Stevie Ray's Comedy Cabaret

9801 Lyndale Avenue South, Bloomington, MN 55420

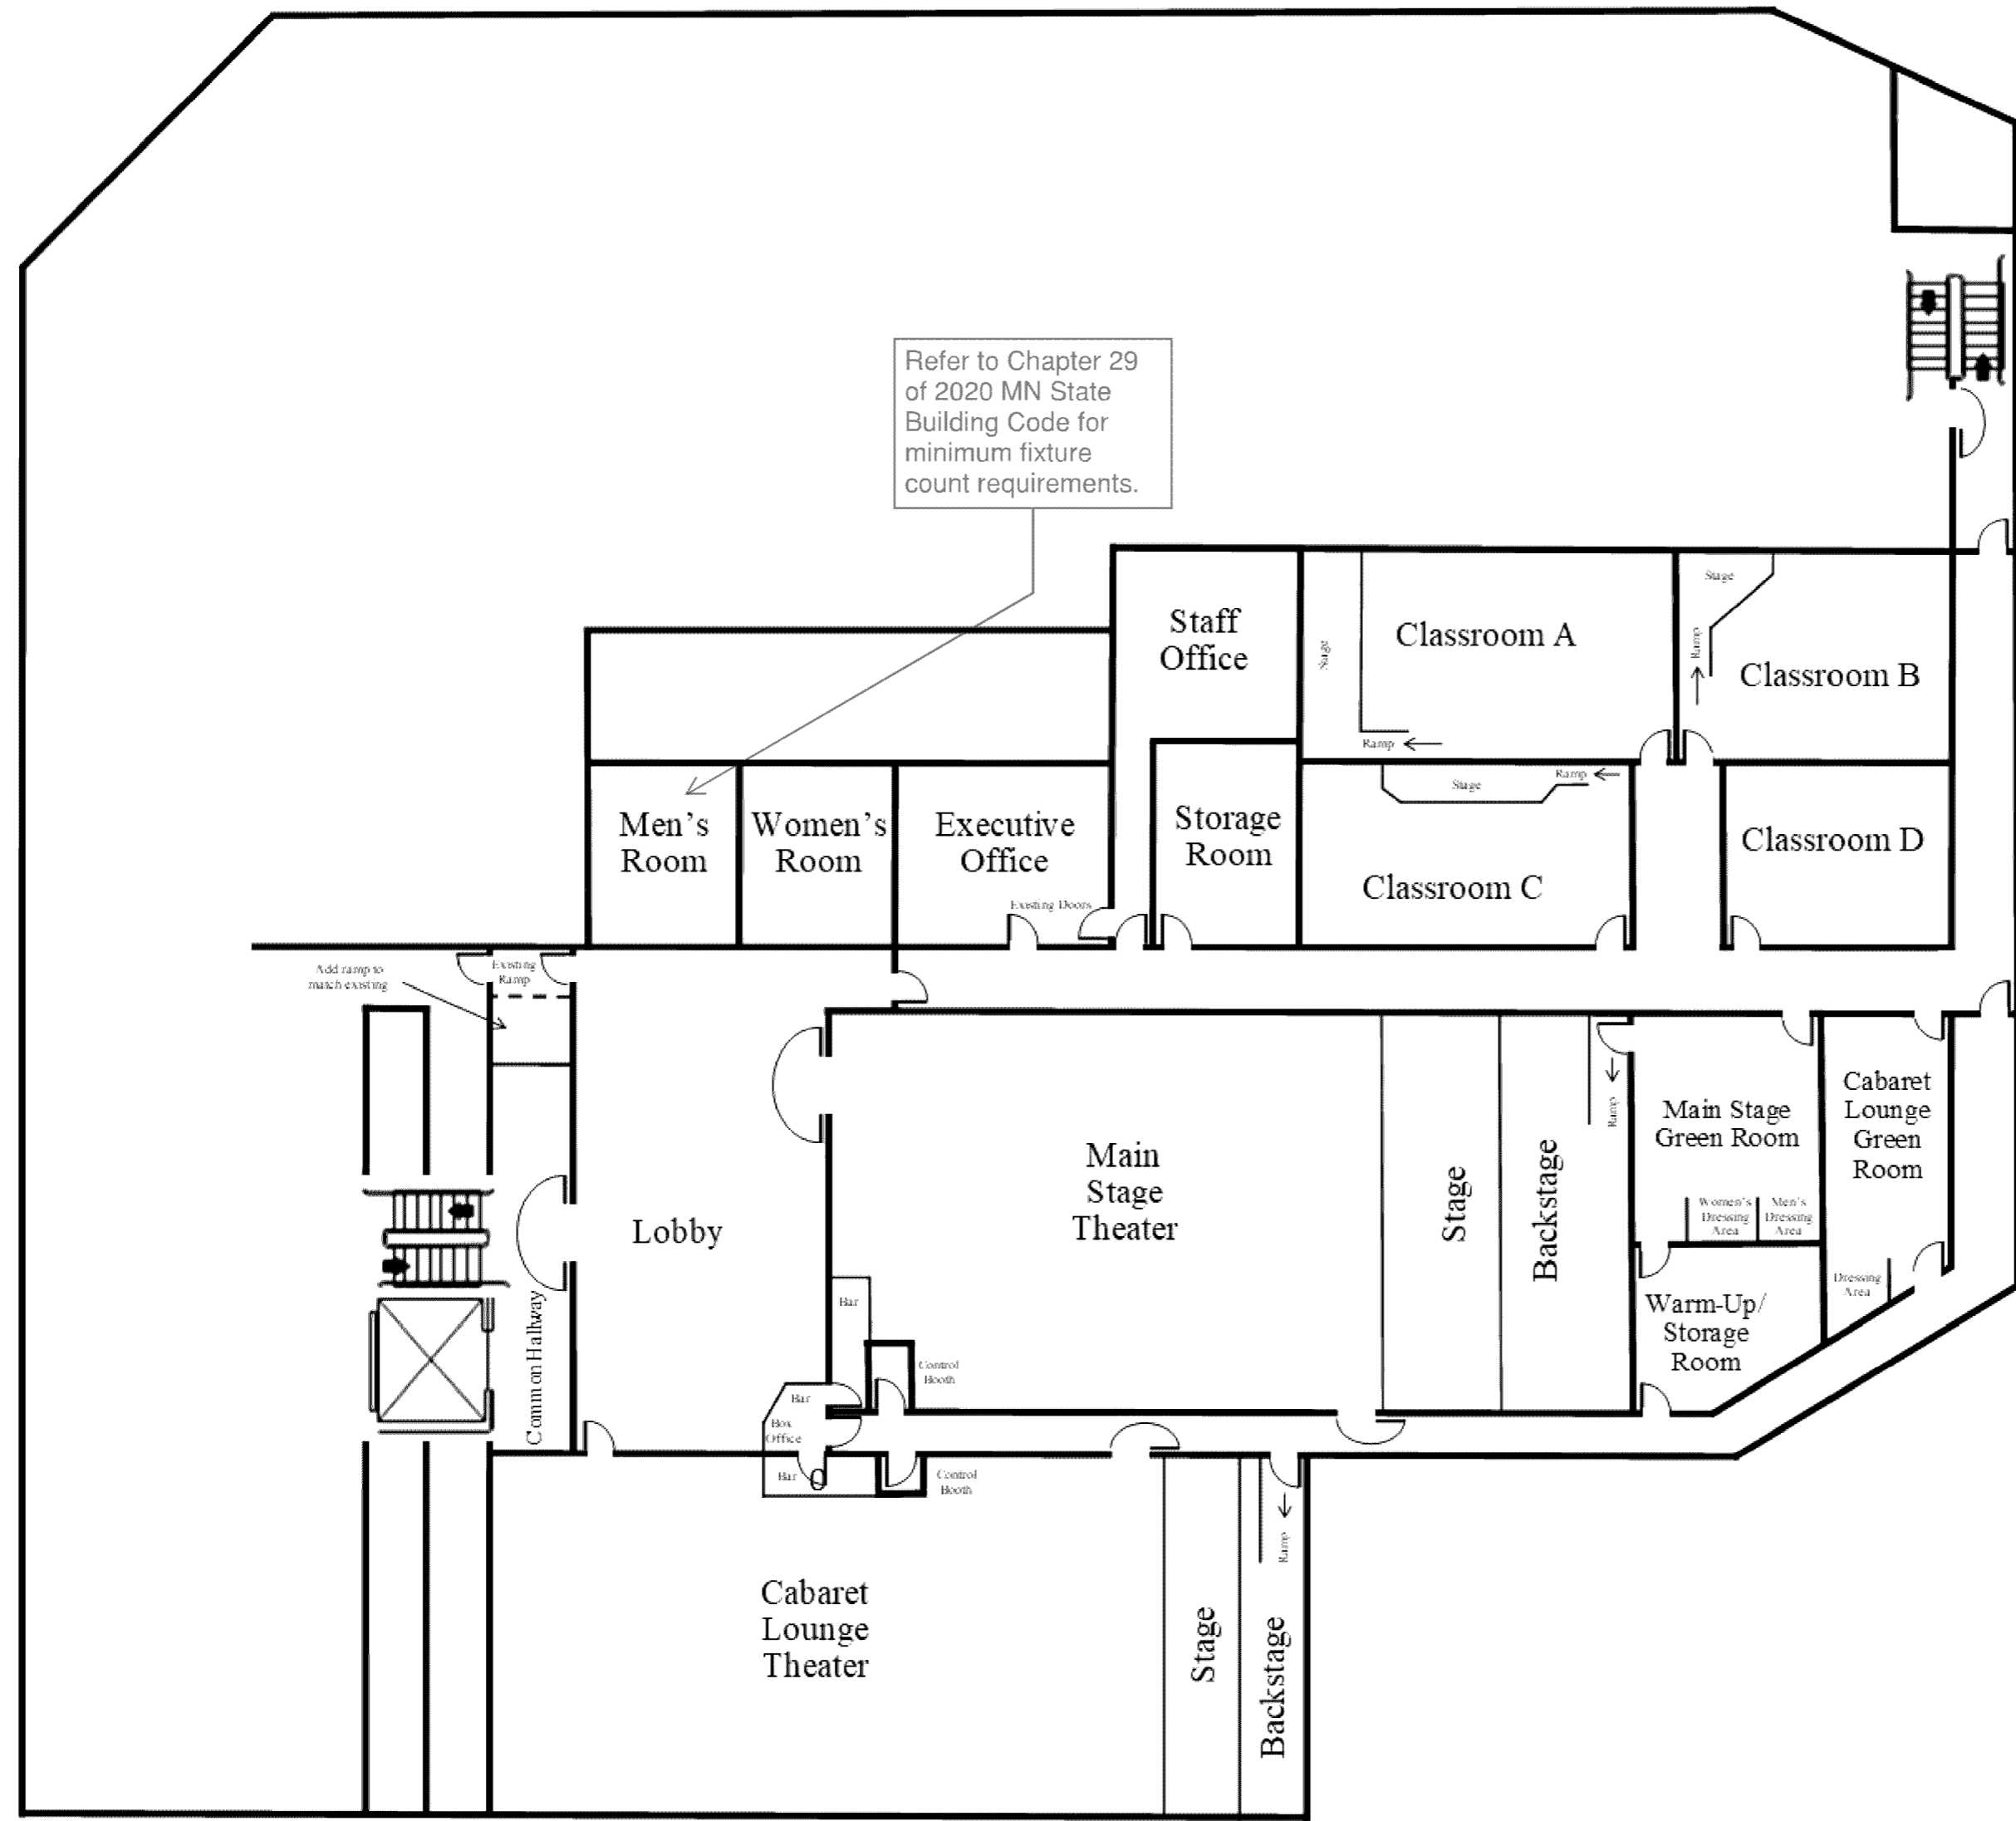
Emergency responder radio coverage meeting the requirements of appendix L in the 2015 MSFC shall be provided throughout the property and within the structures.

Fire alarm system may need to be upgrade for the assembly occupancy.

Entire space(s) must have fully Code complying sprinkler protection.

Building/property shall be adequately signed for emergency response.

Refer to Chapter 29 of 2020 MN State Building Code for minimum fixture count requirements.

Building plans must be signed by a MN licensed architect.

Must meet 2020 MN State Building Code

SAC review by MET council will be required.

Must meet 2020 MN Accessibility Code.

Provide a detailed code analysis with the plans.
